TRUSS LAYOUT/SUBMITTAL REVIEW

JOB No.	2525051
DESCRIPTION	Roeser Homes LLC - Winterset Valley #1464
JOB ADDRESS	125 NW MCKENZIE DR
CITY	Lee's Summit, MO
DESIGNER	Scott Cleverger
DATE	10/30/2020

ROOF
TRUSS LAYOUT

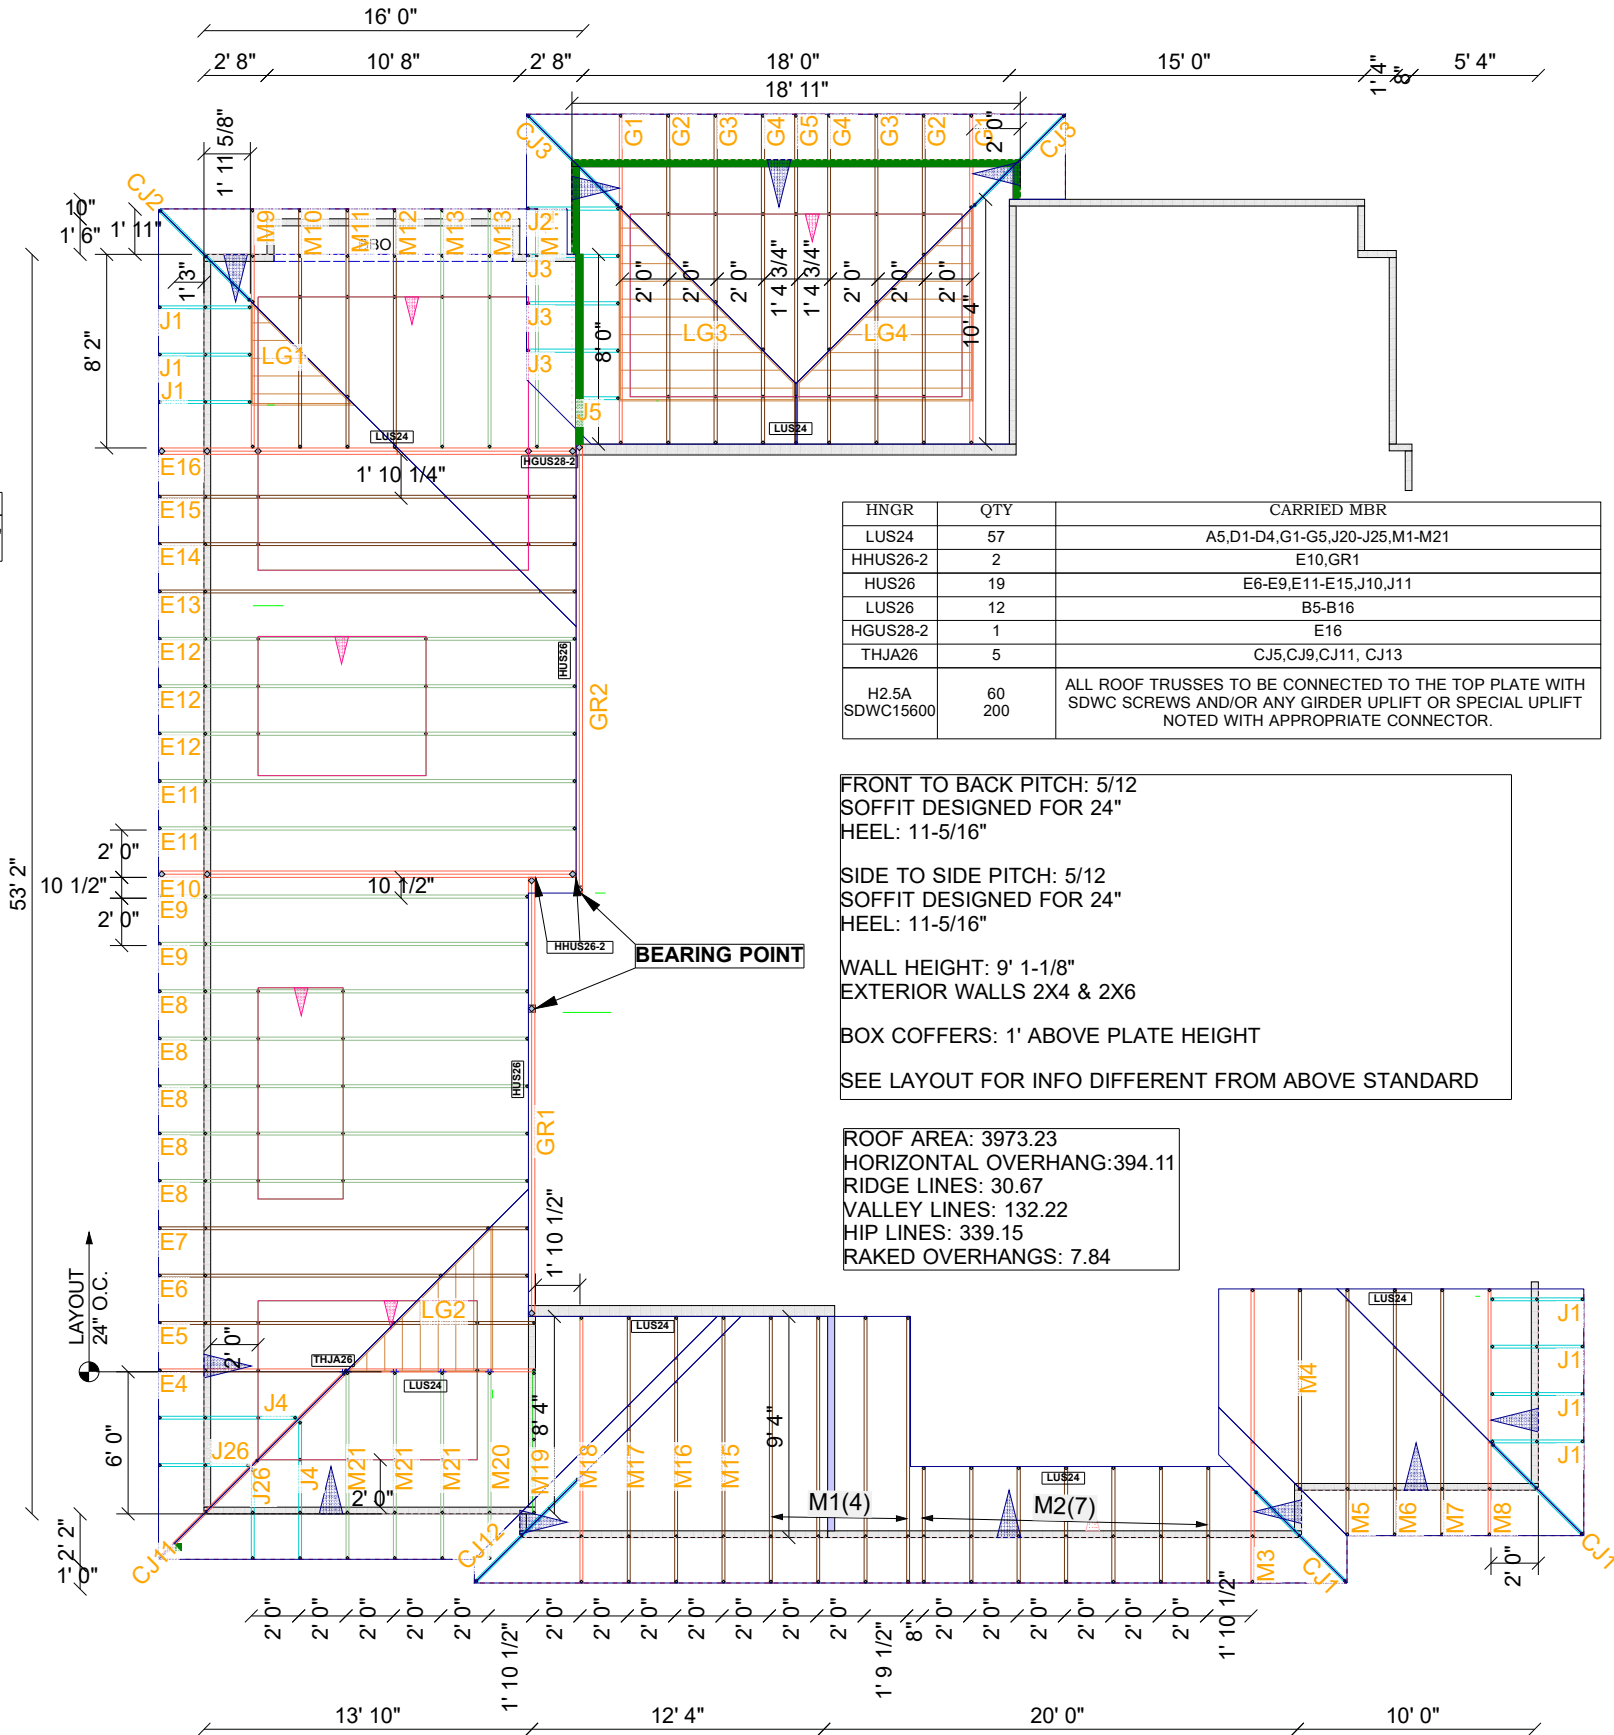
- ☒ REVIEWED & FOUND TO BE IN CONFORMANCE WITH REFERENCED PLAN
- ☐ FURNISH AS CORRECTED
- ☒ REVIEWED WITH CHANGES TO REFERENCED DRAWINGS
- ☐ REVISE AS NOTED & RESUBMIT
